Groundwater Application Review Summary Form

Application # G- 19468

GW Reviewer Travis Brown Date Review Completed: 5/12/2025

TO: Water Rights Section Date 5/9/2025
 FROM: Groundwater Section Travis Brown
 Reviewer's Name
 SUBJECT: Application G- 19468 Supersedes review of _____
 Date of Review(s)

Hydrographs

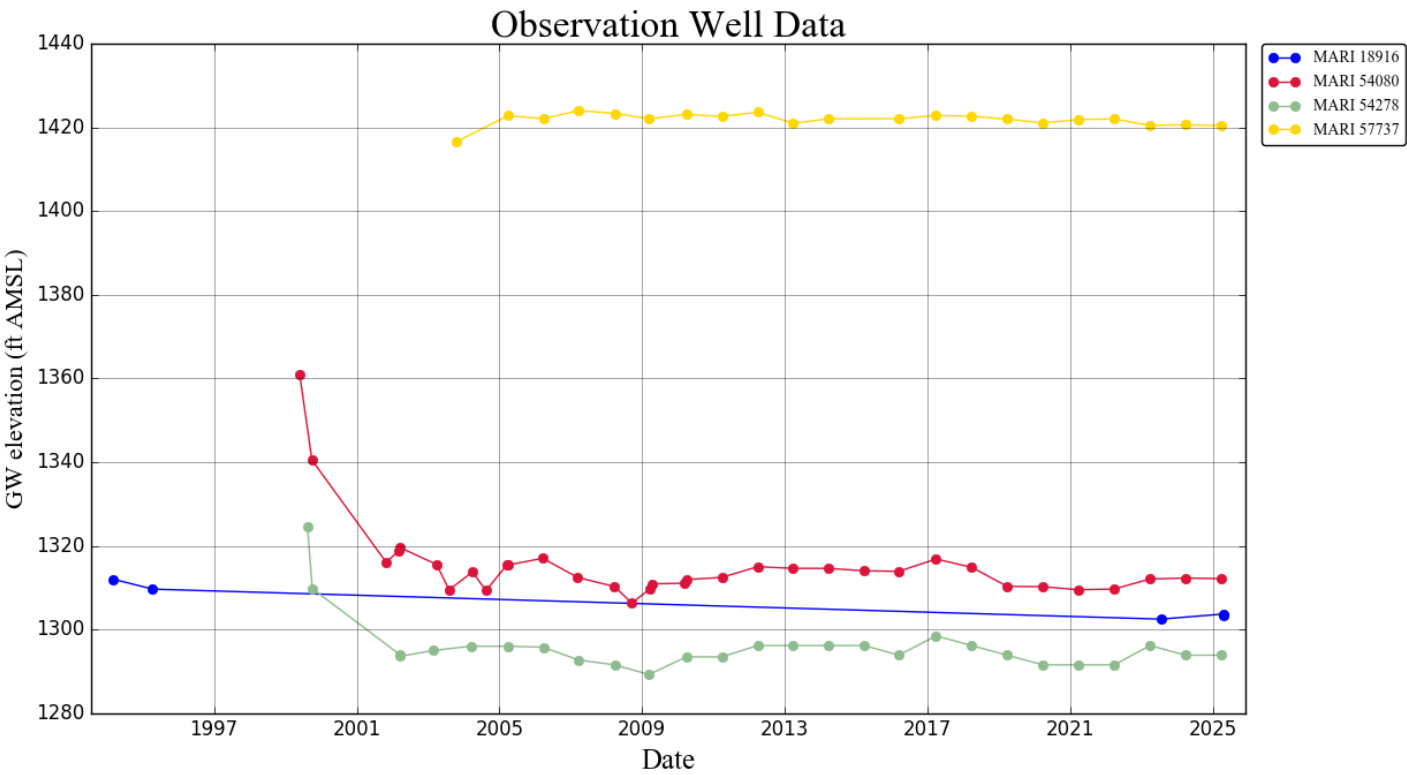
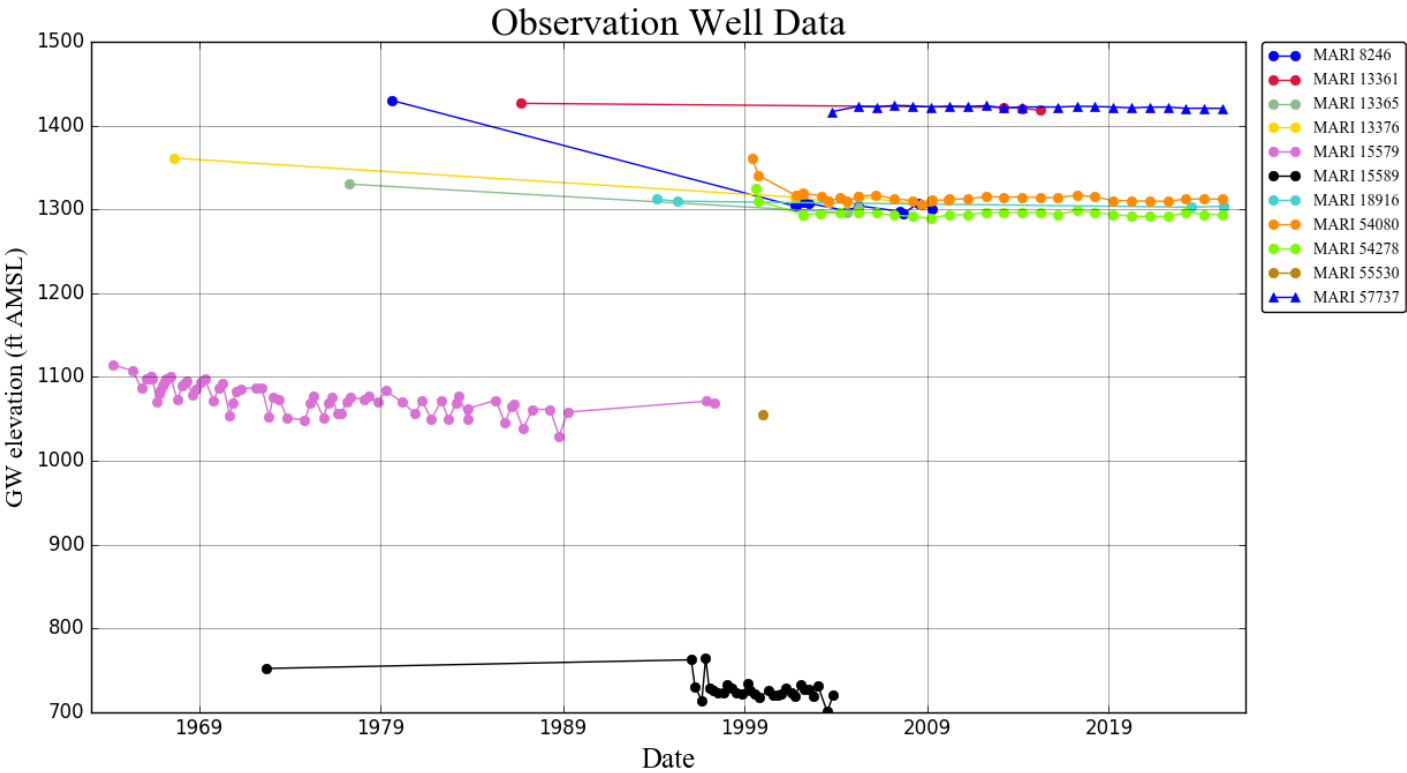
The closest well with any time series water level data is MARI 15579, ~2.5 miles to the southwest of the proposed POA. MARI 15579 exhibited an overall decline in water level of ~56 ft between 1965 and 1989 but showed ~11 ft of recovery between 1989 and 1997, although it was still down ~45 ft from its highest value in 1965; more recent data was not available. The nearest well with recent water level data is MARI 18916, ~2.9 miles northeast of the proposed POA, which has shown an overall decrease in water level of ~8.5 ft since it was drilled in 1994 (see attached Hydrographs). Wells further to the north with current data show relative stability from the early 2000s through 2025 (see attached Hydrographs). However, between 1999 and 2002, MARI 54080 showed an overall decline of ~42.3 ft from the water level reported on its well completion report in 1999. Similarly, between 1999 and 2002, MARI 54278 showed an overall decline of ~31.0 ft from the water level reported on its well completion report in 1999. This pattern of steep initial decline followed by subsequent stabilization may indicate these wells (MARI 54080 and MARI 54278) commingle multiple aquifers. **The preponderance of the current water level data indicates the proposed aquifer is not over appropriated.**
